RE: Percolation Test Report, A546318; 'Miller Property' (12348 Howard Lodge Drive)

## BAT Plan Low Pressure Dosing System Report

Re: Miller Property  
Percolation Certification Plan and Variance  
request

**PERCOLATION CERTIFICATION PLAN**  
**MILLER PROPERTY**  
 LOT 7D  
 TAX MAP 9 GRID 12  
 3RD ELECTION DISTRICT  
 HOWARD COUNTY, MARYLAND  
 PARCEL 306

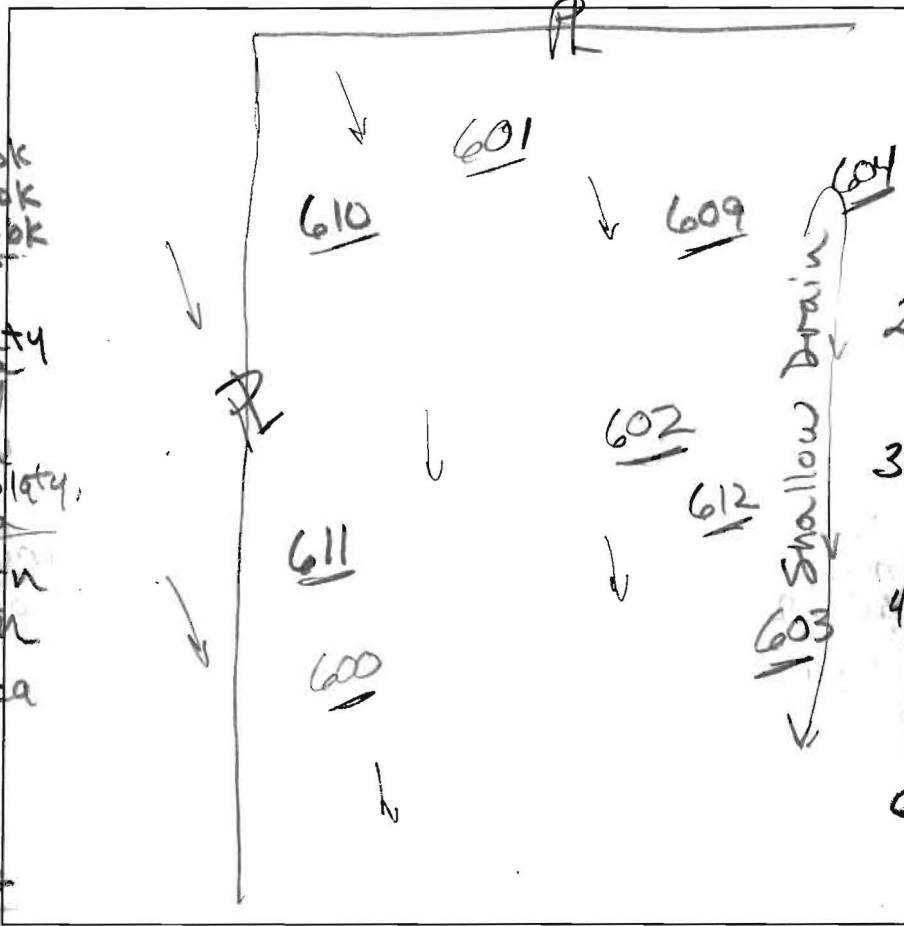
The percolation test Field Worksheet is enclosed with this letter. Only location '601' is a PASS at standard rate for conventional system. Location '602' is a "PASS" at a nonconventional rate. Locations '600', '603', and '604' all FAIL standard percolation testing.

The infiltrometer locations were tested in the layer judged to be the least permable in the top 24 inches of the soils' profiles. Among the infiltrometer tests, location '608' has an infiltration rate of 48 minutes per inch, a conventional PASS. Location '605' has an infiltration rate of 96 minutes per inch, a nonconventional PASS. Together these two locations represent the infiltration rate of a sand mound overlying the area and designed for an infiltration rate of 96 minutes per inch. Location '607' has an infiltration rate exceeding 360 minutes per inch, and is a FAIL.

The percolation test results and suitable area for wastewater discharge are certified by the Approving Authority's signature of the Percolation Certification Plan. The approvable area for the subject property must be at least 10,000 sq.ft. as the lot was created after March 1972. At least two drainfield systems, an initial and one repair must fit into the approvable area.

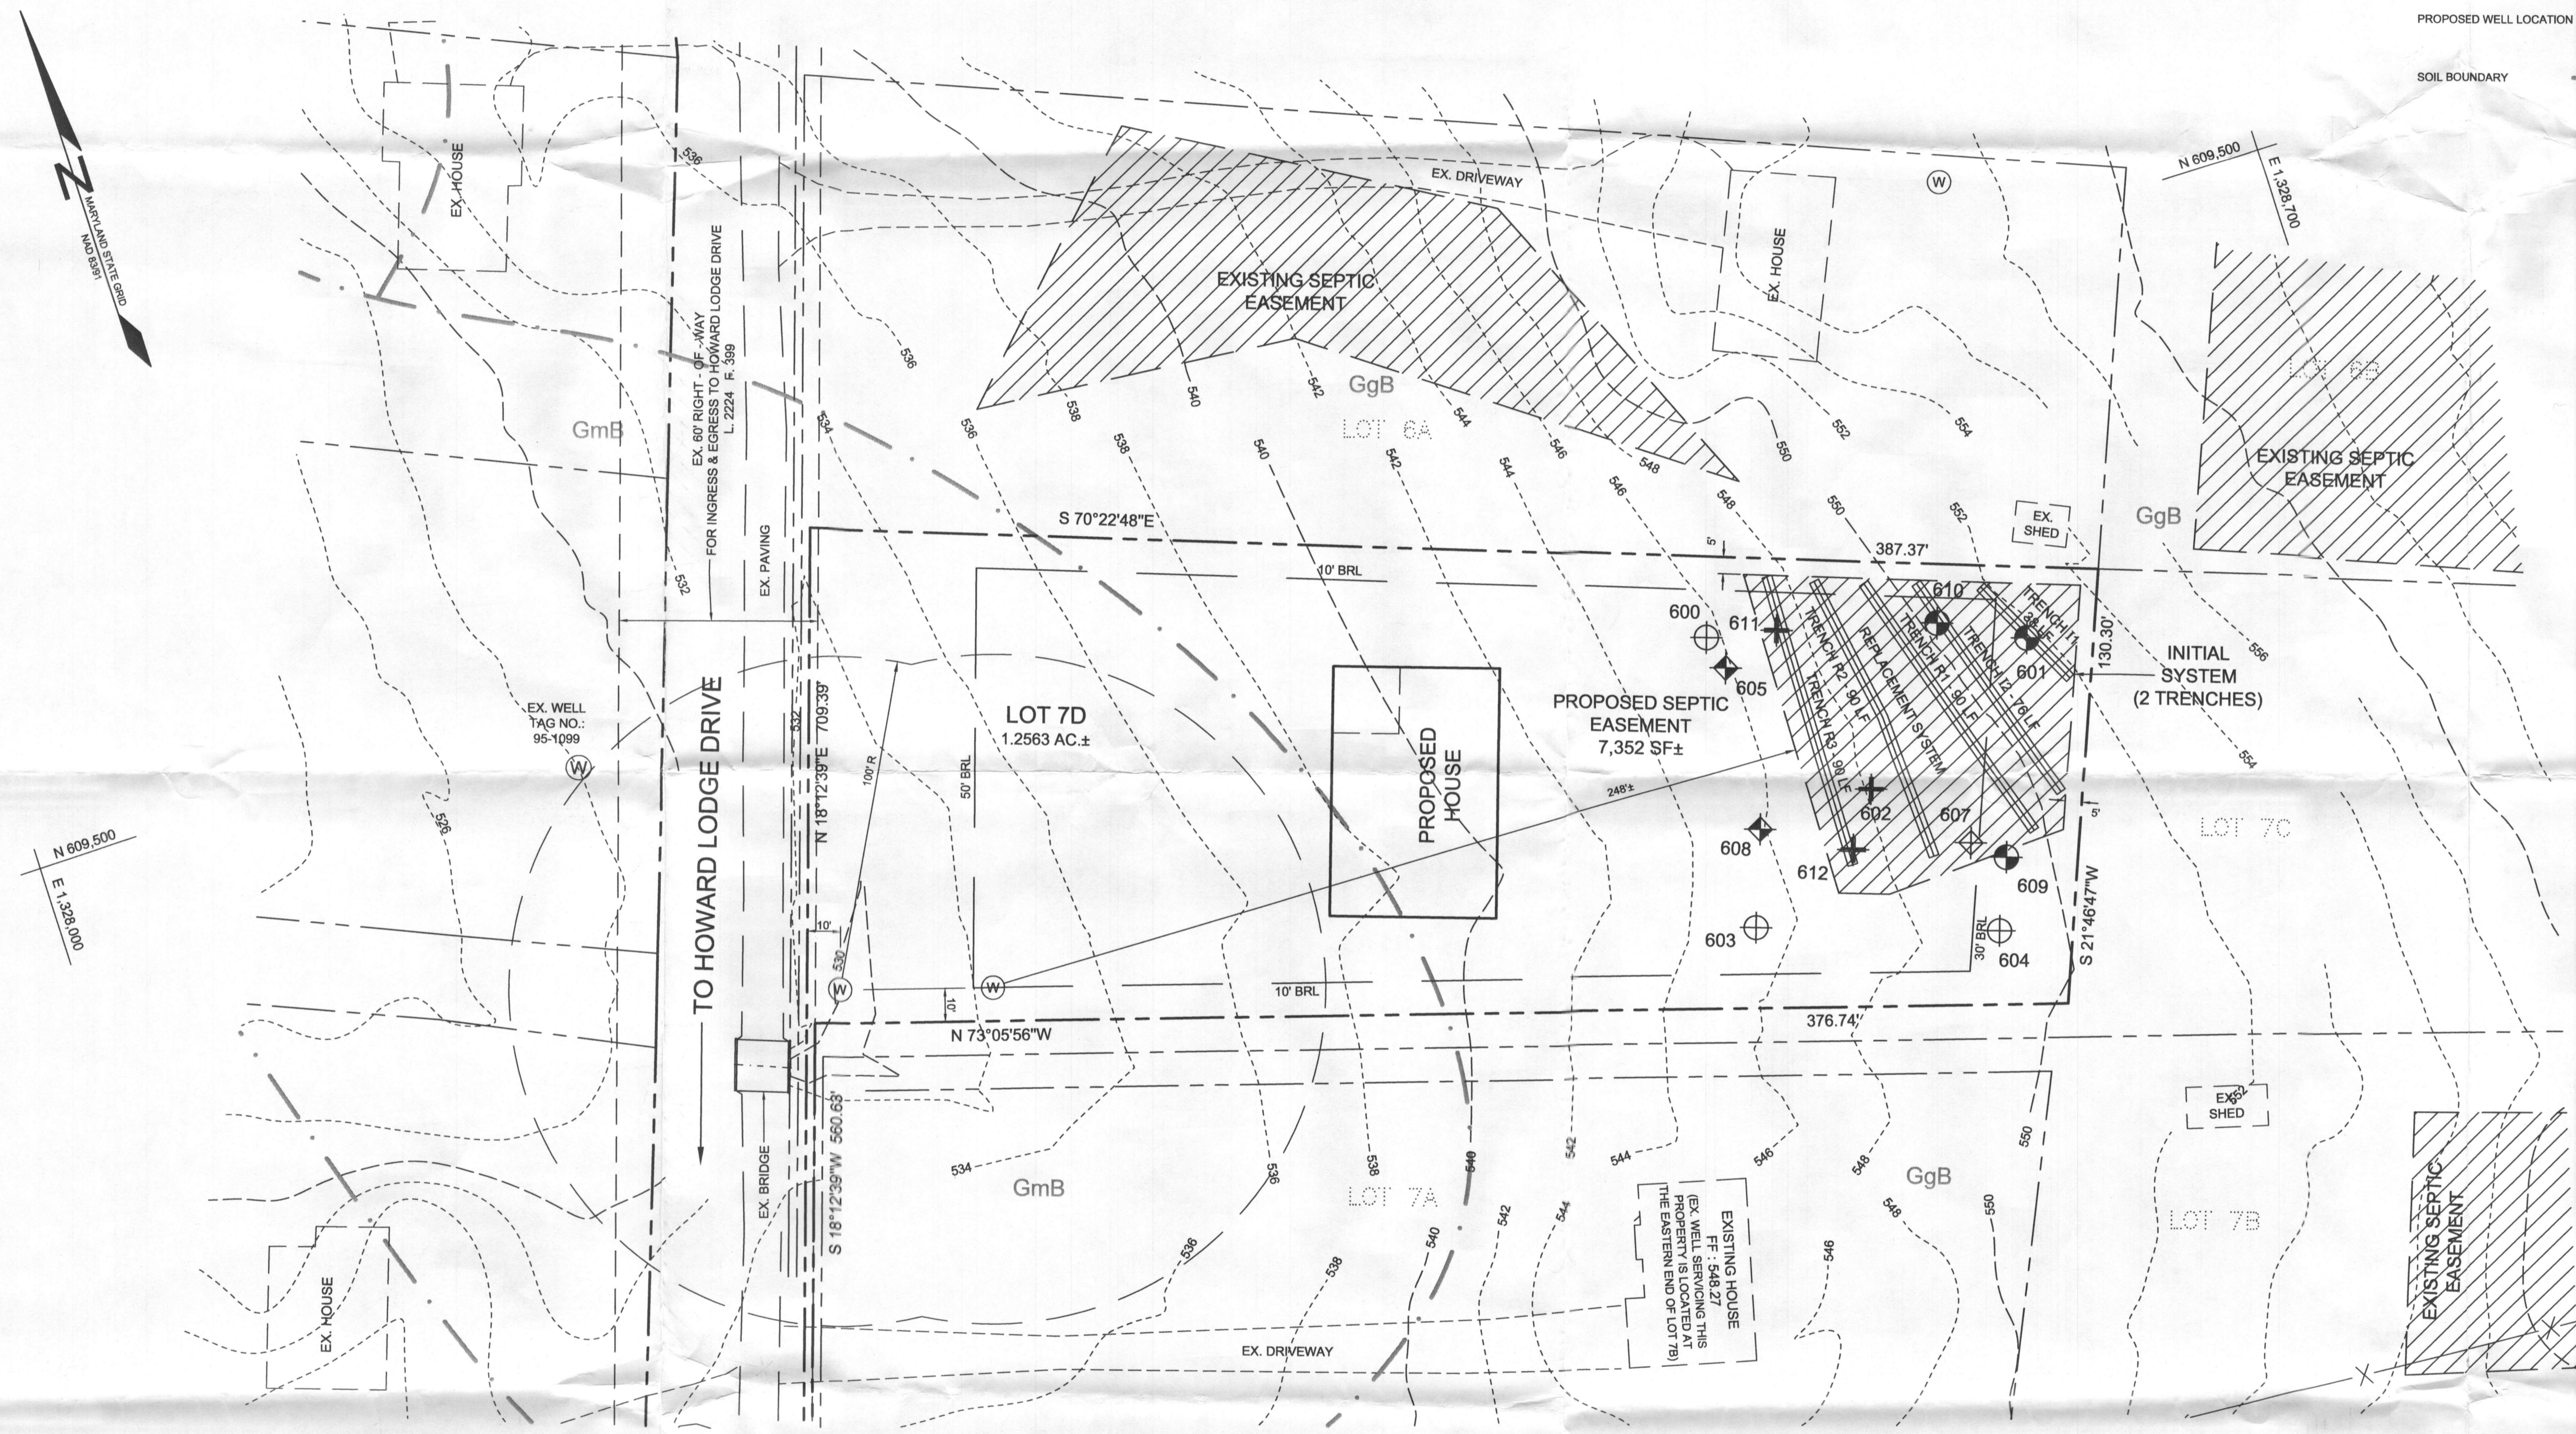
Hi Paul. Hopefully this is the last turnaround for the Miller Property perc cert. Robert sent it up for signature and there were some additional comments when Mike and I reviewed it. See the attached memo. To start, there are some additional requirements because the replacement system is an alternative system under the state regs. This means some additional notes as the memo states

Also, the MDE guidelines for an alternative system with 30-60 mpi perc rates and a low pressure dosed drainfield are that the application rate is 0.4 and there is no sidewall credit available. You'll see that on the spec sheet I attached. I would also like to stay away from using trench 4 down where the standard perc test was pulled and we had just the infiltrometer tests. I think we can do that with the spec sheet I attached. If the first 3 replacement trenches stay where they are but get a bit longer (to around 90' each), you can use a 0.8 rate and 3.5' sidewall for trench 1, which is good for 480 gpd. The bottom two will use a 0.4 rate and no sidewall, which at 180 total linear feet are good for 216 gpd. Added together, that makes 696 gpd for the replacement system, good enough for 4 bedrooms. The design on the BAT plan for this will also be easier because the lower two trenches combined are twice as long as the upper, but have an application rate half as good. Therefore, the system can be designed to make the upper trench receive the same dose as the lower two. You can do this by making two zones with duel alternating pumps or maybe just manipulating hole spacing if they are within the minimum and maximum spacing requirements.
